UNITED STATES PATENT AND TRADEMARK OFFICE

| APPLICATION NO. | FILING DATE | FIRST NAMED INVENTOR | ATTORNEY DOCKET NO. | CONFIRMATION NO. |
|-----------------|-------------|----------------------|---------------------|------------------|
| 09/540,113      | 03/31/2000  | Wolfgang Renz        |                     | 2414             |

# Office Action Summary

**DETAILED Non-Final ACTION**

U.S. Patent Oct. 24, 1996 Sheet 2 of 2 4,620,155

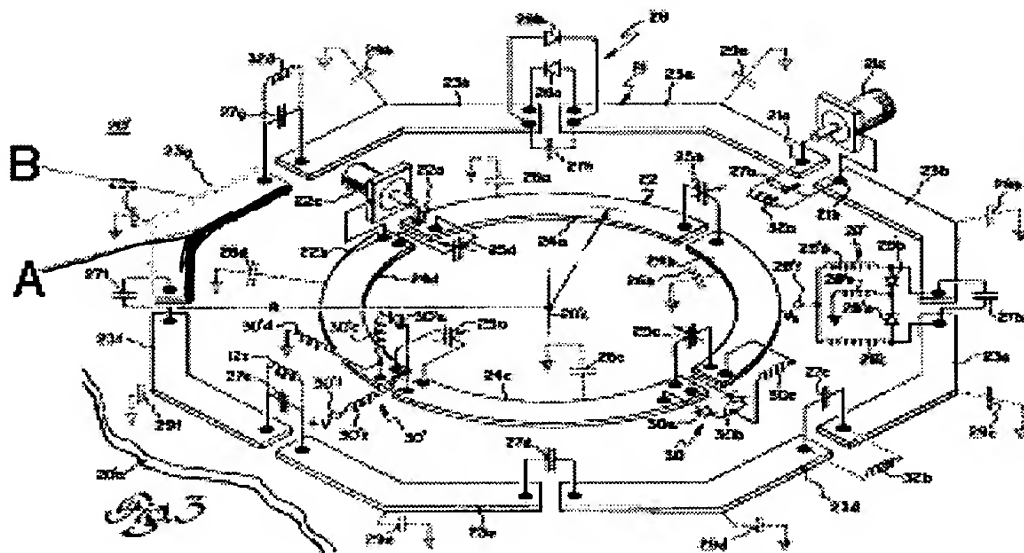
10 With respect to **Claim 1**, **Edelstein** teaches an NMR Antenna subsystem that has a plurality of co-planar surface coils, each comprised of a plurality of segments and elements. [See abstract, Figure 3 which is interpreted broadly as a multi element NMR antenna, because an NMR application is suggested in the abstract, and col. 3 lines 3-36] **Edelstein** suggests and shows “a plurality of antenna elements” (i.e. segmental elements 23a-h) , [See Figure 3] “each antenna having an element beginning” (i.e. the inner surface of component 23-g; which has been indicated by examiner notation as component **A** in the figure below; ) “and an element end” (i.e. the outer surface of component 23-g; which has been indicated by examiner notation as component **B** in the figure below; ) [See Figure 3]; “said antenna elements being disposed radially relative to a center axis” (i.e. the definition of radial being used by the examiner is definition number 4 of <sup>1</sup>radial on page 962 of Merriam Webster’s Collegiate Dictionary

Tenth Edition 1997 "developing uniformly around a central axis", and the components of **Edelstein** meet this conventional well-known definition of radial. The **Edelstein** reference shows that the antenna elements are arranged "radially relative to a center axis so as to proceed outwardly from the respective element beginnings (i.e. inner surface A) "to the respective element ends"; (i.e. outer surface B) [See Figure 3] "and exhibit cyclical symmetry from antenna element to antenna element;" [See Figure 3] The examiner notes that each of the "said antenna elements" (i.e. the segmented elements 23a-h) have an inner surface A and an outer surface B "being at least magnetically coupled with each other," [See Figure 3, col. 2 lines 18-51] "and said plurality being at least five" [See Figure 3 which shows at least 8 segmented antenna elements].

11 The examiner notes that using the definition for radial as "developing uniformly around a central axis" the, **Ed Istein** reference meets the requirements of claim 1,

because components 23a through 23h are developed uniformly around a central axis represented by point 20'c in Figure 3.

12 With respect to **Claim 2**, **Edelstein** shows and suggests that “the respective element beginnings (i.e. surface A in Figure 3) “and the respective element ends” (i.e. surface B in Figure 3) are also connected to ground”. [See Figure 3 components 29a through 29h] The same reasons for rejection, that apply to **claim 1** also apply to **claim 2**.

13 With respect to **Claim 3**, **Edelstein** shows, teaches and suggests that “said antenna elements are electrically coupled to each other.” [See Figure 3, components 23a through 27h; col. 4 lines 13-29; and the entire reference in general.] The same reasons for rejection, that apply to **claim 1** also apply to **claim 3**.

14 With respect to **Claim 8**, **Edelstein** shows, and suggests from the diagram of Figure 3, that “the respective element beginnings define an element beginning plane and wherein the respective element ends defines an element end plane, and wherein said element beginning plane and said element end plane are parallel to and spaced from each other.” [See Figure 3] The same reasons for rejection, that apply to **claim 1** also apply to **claim 8**.

15 With respect to **Claim 9**, **Edelstein** shows, and suggests from the diagram of Figure 3, that “the respective antenna elements are linear.” [See Figure 3] The same reasons for rejection, that apply to **claims 1, 8** also apply to **claim 9**.

line directions intersecting said center axis at a common point", [See Figure 3 center point 20'c which is the center of angulated ring 23 and inner ring 24. Additionally, Figure 3 suggests that all the segmented components have the same central axis point.] The same reasons for rejection, that apply to **claims 1, 8**, also apply to **claim 10**.

17 With respect to **Claim 11**, **Edelstein** teaches, shows, and suggests from the diagram of Figure 3 "a grounding plate disposed parallel to said element beginning plane and said element end plane, and said common point being disposed in said grounding plate." [See Figure 3]. The same reasons for rejection, that apply to **claims 1, 8, 10** also apply to **claim 11**.

18 With respect to **Claim 12**, **Edelstein** teaches, shows, and suggests, from the diagram of Figure 3, a "grounding plate disposed parallel to said element beginning plane and said element end plane." [See Figure 3] The same reasons for rejection, that apply to **claims 1, 8**, also apply to **claim 12**.

19 With respect to **Claim 13**, **Edelstein** shows, and suggests, from the diagram of Figure 3 that the plurality of angulated antenna segments is 8, and a plurality of 8 angulated segments is inherently "divisible by 4". Therefore, **Edelstein** teaches, shows, and suggests, that the plurality of antenna segments "is divisible by 4". The same reasons for rejection, that apply to **claim 1**, also apply to **claim 13**.
